## Product Change Notification

### TE Connectivity

Product Change Notification: E-20-015569

Modification PT relay base

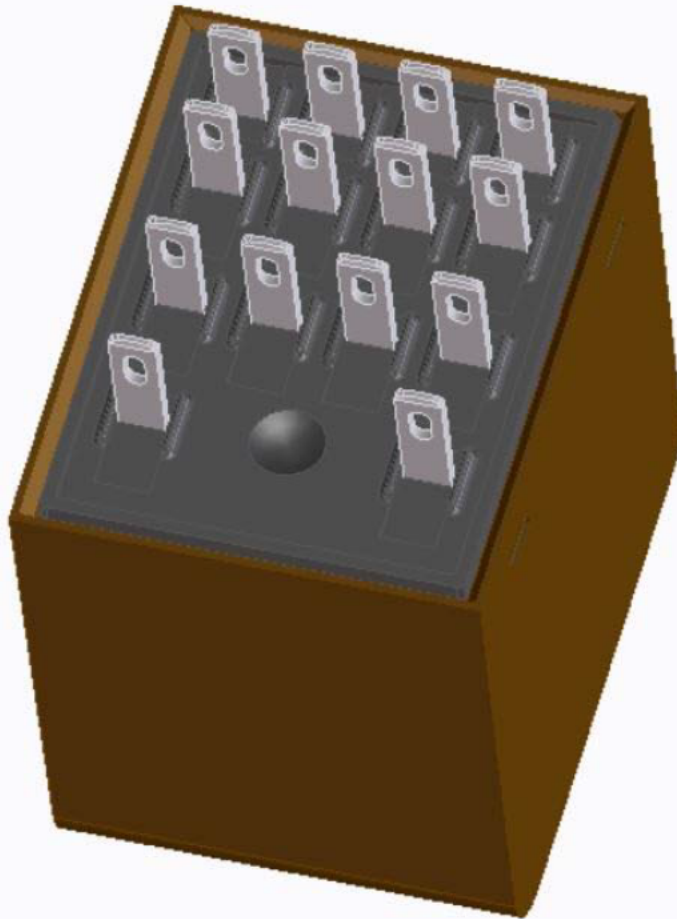
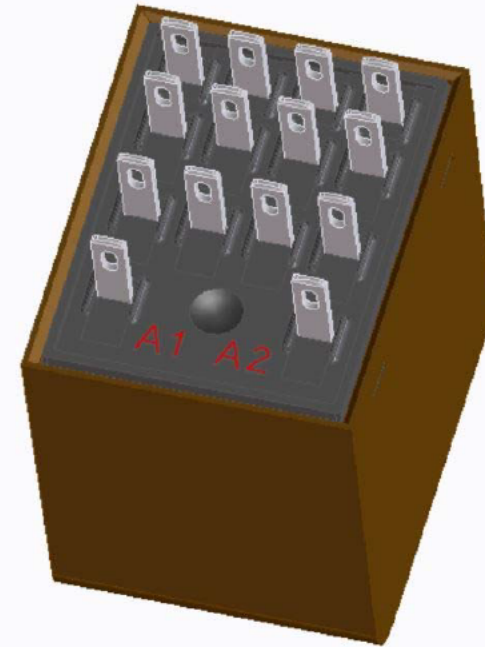
At the bottom of the relay base coil pin indicators were added, see red marked area. These indicators were added in the mold of the base and will protrude a maximum of 0.2mm. The modifications do not have any influence of the specification or behavior of the relay.

Product Improvement. This modification can help customers to identify the correct coil pins. Especially at coils with a protection diode the customers can assign the correct polarity.
